ENVIRONMENTAL ASSESSMENT

CONSTRUCTION OF A NEW ENTRY GATE COMPLEX

AT HOMESTEAD AIR RESERVE BASE

May 2010

Figure 3-3. Major Surface Water Bodies in the Project Vicinity

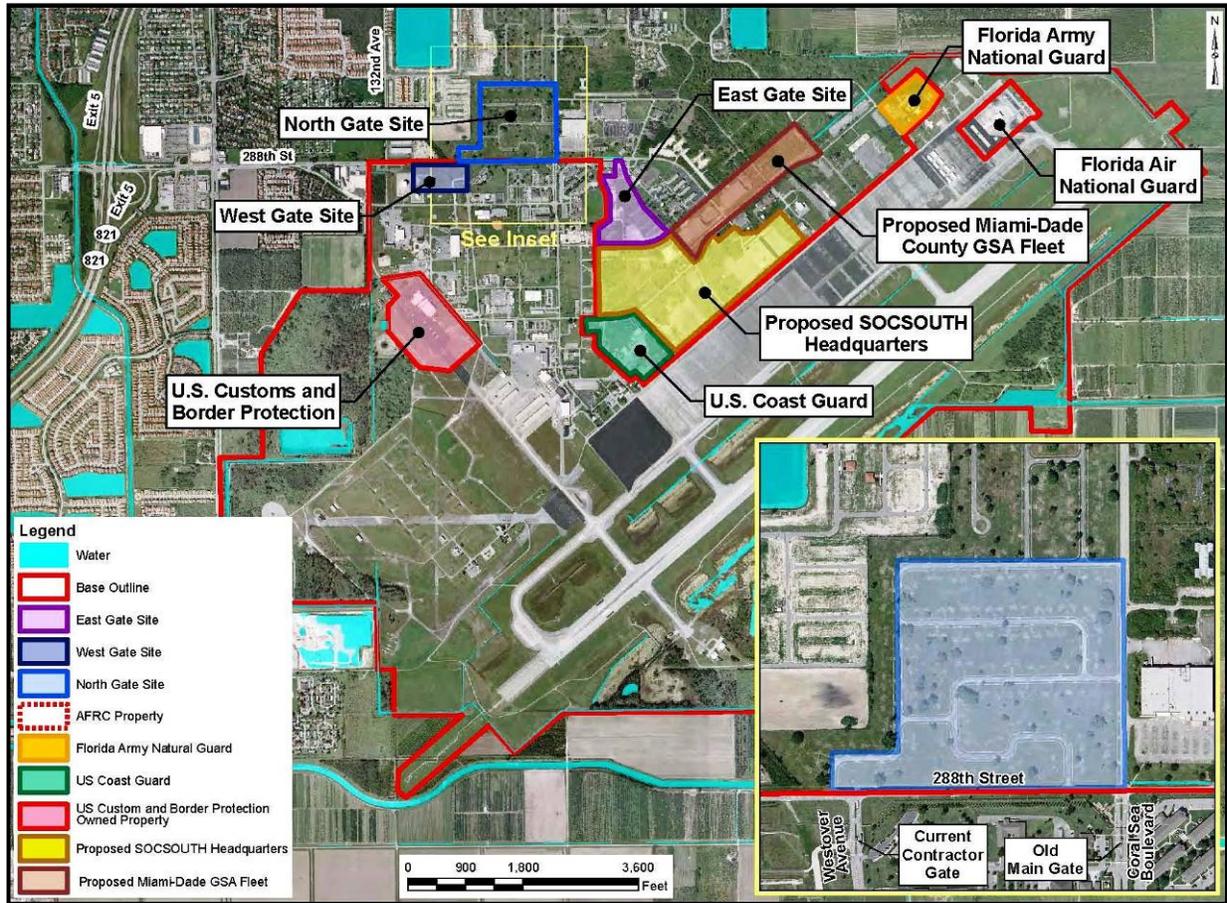
Florida Department of Transportation (FDOT) District Six staff has reviewed the proposed project and recommends that Figure 3-3, "Major Surface Water Bodies in the Project Vicinity" be revised, as area water bodies are not identified on the figure. It appears that the incorrect figure may have been included in this section.

FDOT's District Six staff recommends that Figure 3-3, "Major Surface Water Bodies in the Project Vicinity" be revised, as the water bodies referenced in the text are not identified on the figure. It appears that the incorrect figure may have been included in this section. The FDOT Aviation Office has no comments.	
ENVIRONMENTAL PROTECTION - FLORIDA DEPARTMENT OF ENVIRONMENTAL PROTECTION	
DEP staff confirms that project managers will need to obtain a National Pollutant Discharge Elimination System (NPDES) permit from the DEP, including a Stormwater Pollution Prevention Plan (SWPPP) detailing site-specific best management practices (BMPs) to control erosion. For further information and assistance, please contact the DEP's NPDES Stormwater Section in Tallahassee at (850) 245-7522.	
SOUTH FLORIDA WMD - SOUTH FLORIDA WATER MANAGEMENT DISTRICT	
The proposed project does not appear to involve wetlands, as defined by Rule 62-340, F.A.C., or other surface waters. The history of storage, handling and reported spills of petroleum products in this area warrants pre-screening of any excavated soil for hydrocarbon contaminants by a licensed environmental professional. Should contaminated soil be detected, the necessary county and state reporting and remediation procedures should be conducted. A Water Use Permit will be required for any proposed construction dewatering activities. Potential issues of concern related to any proposed construction dewatering activities include saltwater intrusion and movement of dissolved phase hydrocarbons in the groundwater.

1. Figure 3-3, Major Surface Water Bodies in the Project Vicinity – The water bodies referenced in the text are not identified on the figure. It appears that the incorrect figure may have been included in this section.

Figure 3-8. Possible Redirected Metrobus Routes

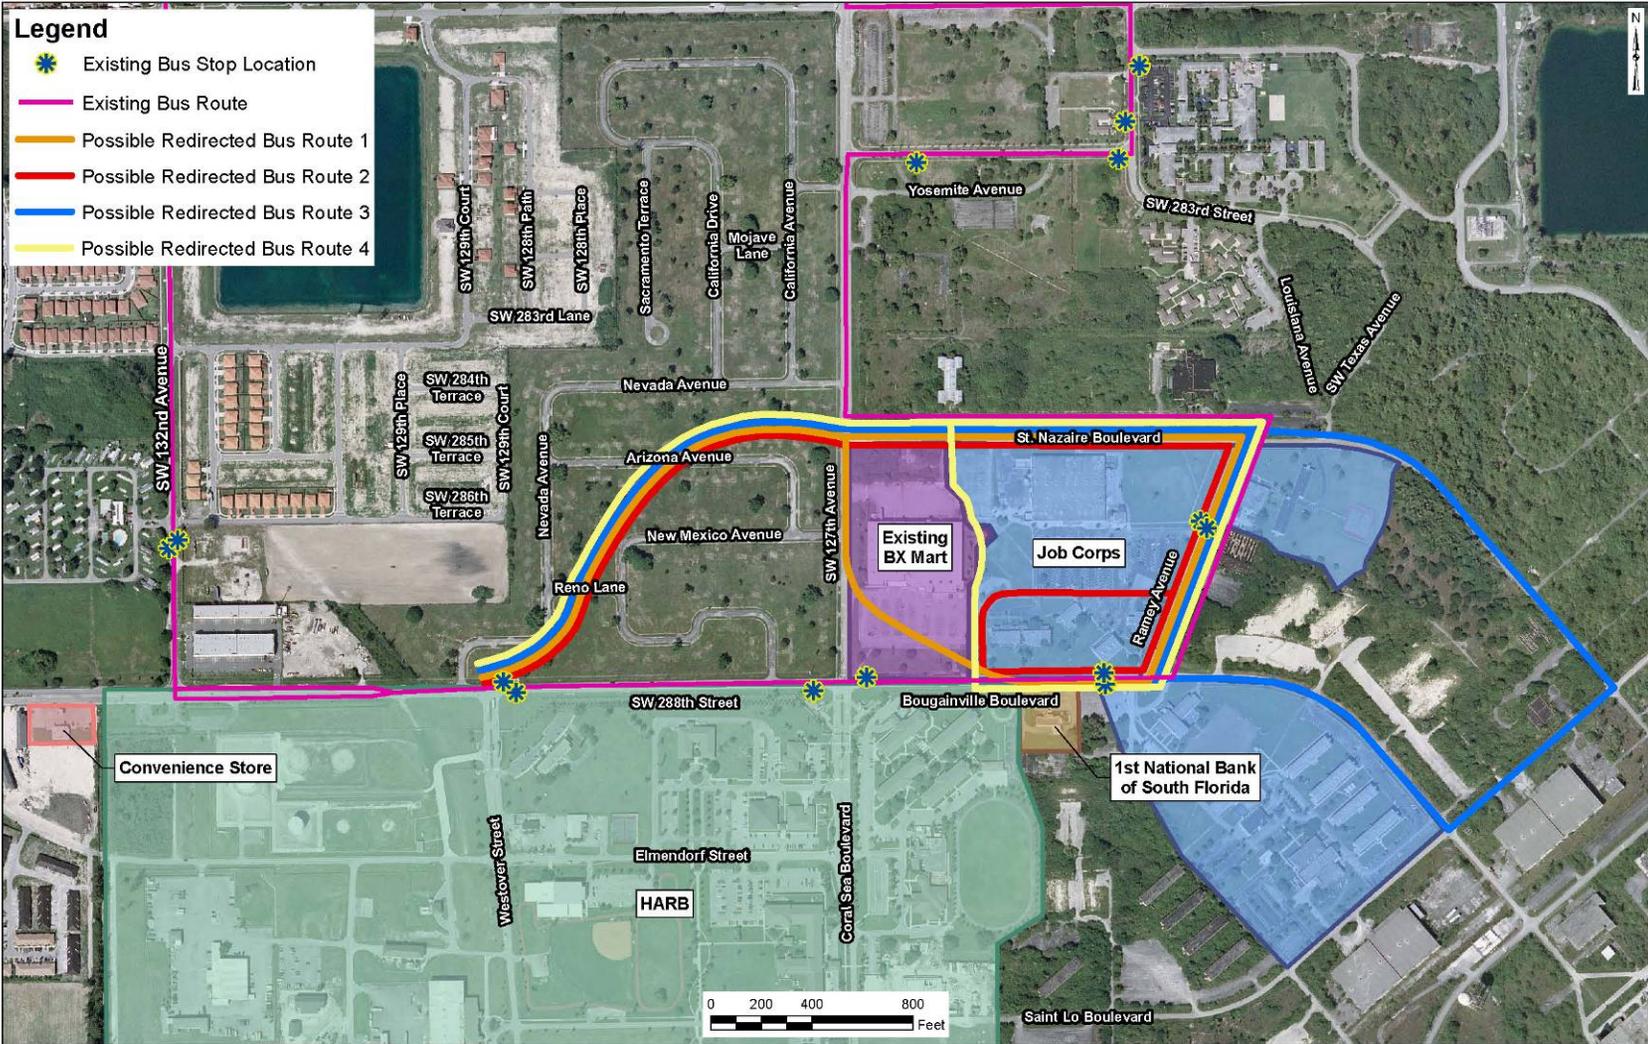
As for the proposed Alternative Bus Route deviations discussed on pages 3-45 to 3-48 on the Draft EA document; # 1 is the most operationally feasible because it would only require an additional minute of run time and be the option that most resembles the Route 70's existing alignment. MDT's foremost concern would be the design of the proposed conversion of a roadway through the BX Mart parking lot as depicted on Figure 3-8. Metrobus service is mainly operated with 40-foot vehicles and the initial short distance turns off of SW 127th Avenue appear too sharp to be properly executed. A more reasonable accommodation may be a more gradual veering turn along the landscaped buffer between the existing BX Mart parking area and Bougainville Boulevard. This new roadway could run parallel along the illustrated fencing or shrubbery barrier in the site plans. The other obstacle to this option would be how the road conversion is funded and completed. Miami-Dade County's Public Works Department would have to fund and construct this new roadway connection unless it was included in this project's scope of work. Proposed Alternate Bus Route # 1 is not operationally feasible without a new roadway connection between SW 127th Avenue and Bougainville Boulevard.
